COMPLIANCE WITH CONDITION 6(a) and 6(d)

Reg Ref: SD21A/0327
Location: Proposed Residential Development at Gordon Park, Old Naas Road, Kingswood, Dublin 22.
Applicant: Greenwalk Development Ltd.

Figure 1 – Screenshot from lighting plan indicating limited illumination of sensitive eastern boundary

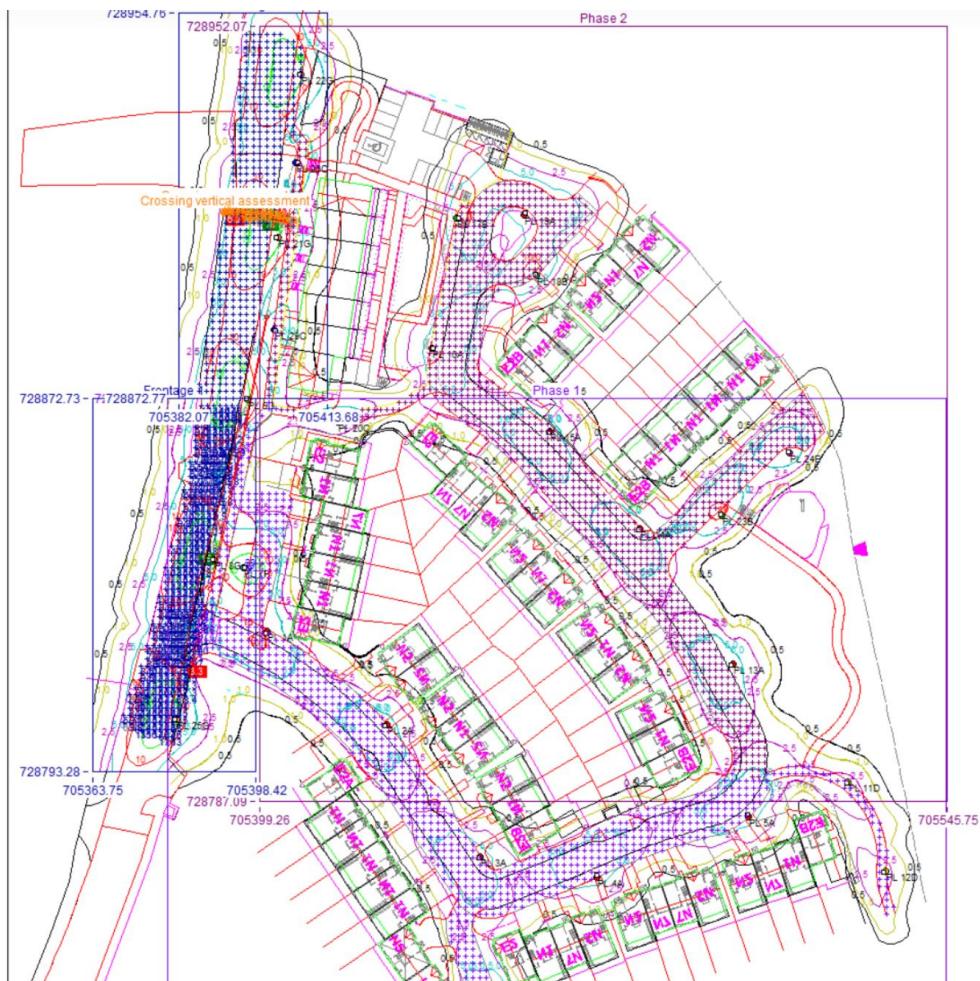
Gannon + Associates have reviewed the reviews Public Lighting Plan prepared by Patrick Redmond and are satisfied that the scheme provides an adequate balance between the public safety at night and ecological photoreceptors. We can confirm that the detail of measures described under "Mitigation Measure 4: Night Time Lighting" in the Ecological Impact Assessment has been adhered to in this final lighting plan.

- The lighting configuration has been carefully selected to achieve recommended illuminance levels whilst minimising light spill and avoiding over lighting. This is achieved by a combination of optimised column height, luminaire Wattage, optical setting and column location for each road configuration.
- All luminaires proposed have high performance street lighting specific optics designed to get the light onto the target area thus minimising spill light.
- All luminaires proposed have a 0 degree tilt.

- The ULR of all proposed column mounted luminaires is 0%.
- All luminaires are to be neutral white colour temperature with peak wavelength of above 550nm and max.
- All column mounted luminaires are to be fitted with photocells which automatically switch luminaires on during night time and off during daytime.
- Additionally, all column mounted luminaires are to automatically dim to 75% 00:00 – 06:00 (U14 profile). If required and with agreement of the local authority additional dimming is available.
- No direct lighting of existing hedgerow at eastern boundary and proposed tree and hedge planting.
- Green space to remain largely unlight.
- Vertical light spill at light sources is below 3m.
- No floodlighting is proposed.
- Night timer lighting kept to a minimum during construction phase.
